802.3bj Draft 1.3 Comment #191

AN_LINK.indication primitive when using CAUI and XLAUI

IEEE P802.3bj Task Force

Comment #191

Figure 73–11—Arbitration state diagram

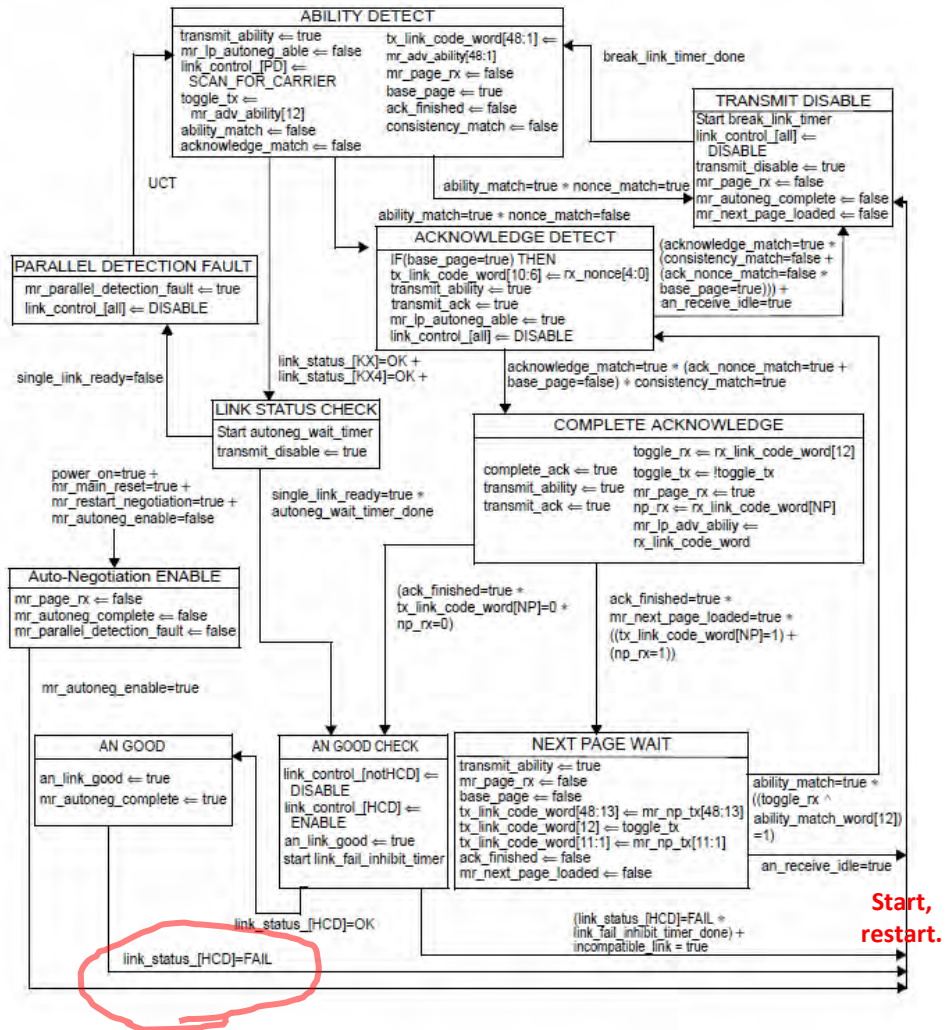
When link_status changes to FAIL, a link restart is triggered by going to TRANSMIT_DISABLE state.

10G Layer Architecture

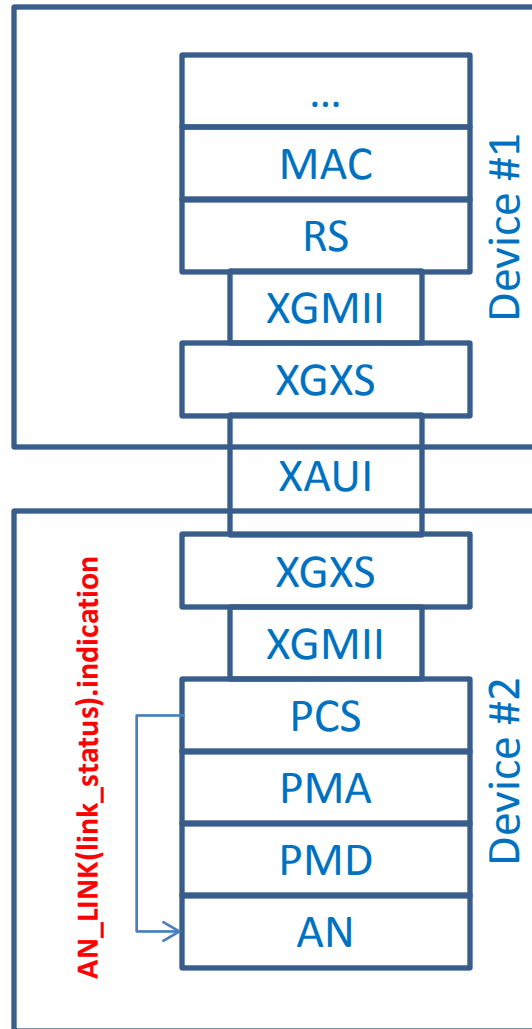
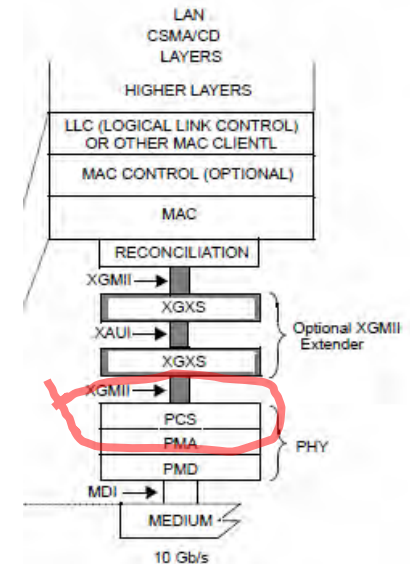
When PHY spans more than one device, interconnect is via XAUI. The PCS is still on the device with AN.

No problem!

40G/100G layer architecture

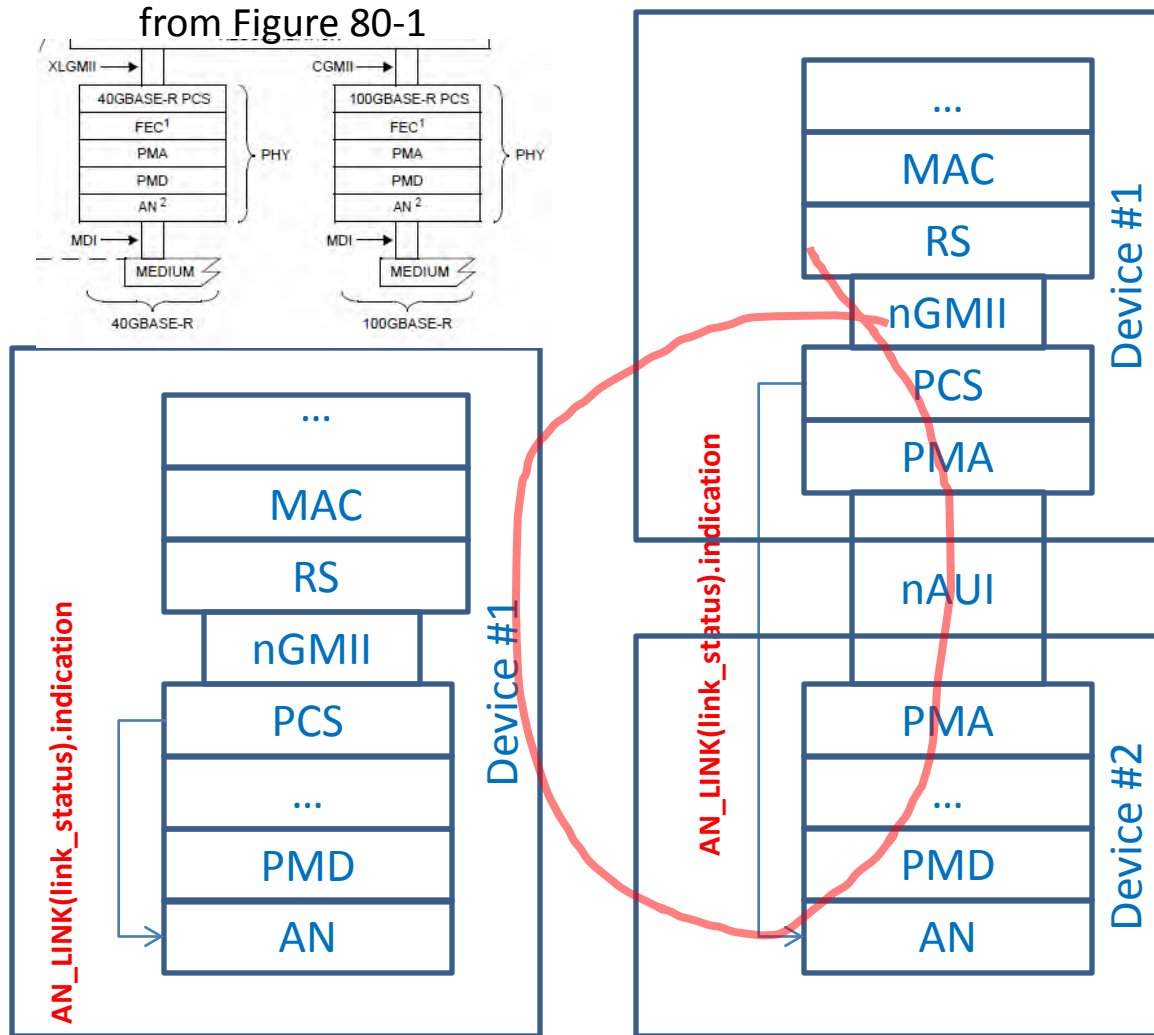
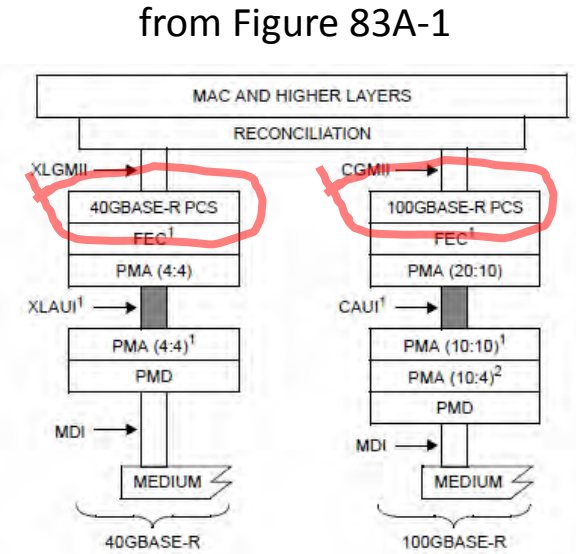
When PHY spans more than one device, interconnect is via nAUI. PCS is on a different device than AN.

How to connect the two together?

Add the following paragraph to 84.3, 85.3, 92.3, 93.3, 94.3.2.

The <PHY type> PHY may be extended using the {XLAUI, CAUI} as a physical instantiation of the inter-sublayer service interface between devices. If {XLAUI, CAUI} is instantiated, the AN_LINK(link_status).indication must be relayed from the device with the PCS sublayer to the device with the AN sublayer by means at the discretion of the implementer. As examples, the implementer may employ use of pervasive management or employ a dedicated electrical signal to relay the state of link_status as indicated by the PCS sublayer on one device to the AN sublayer on the other device.
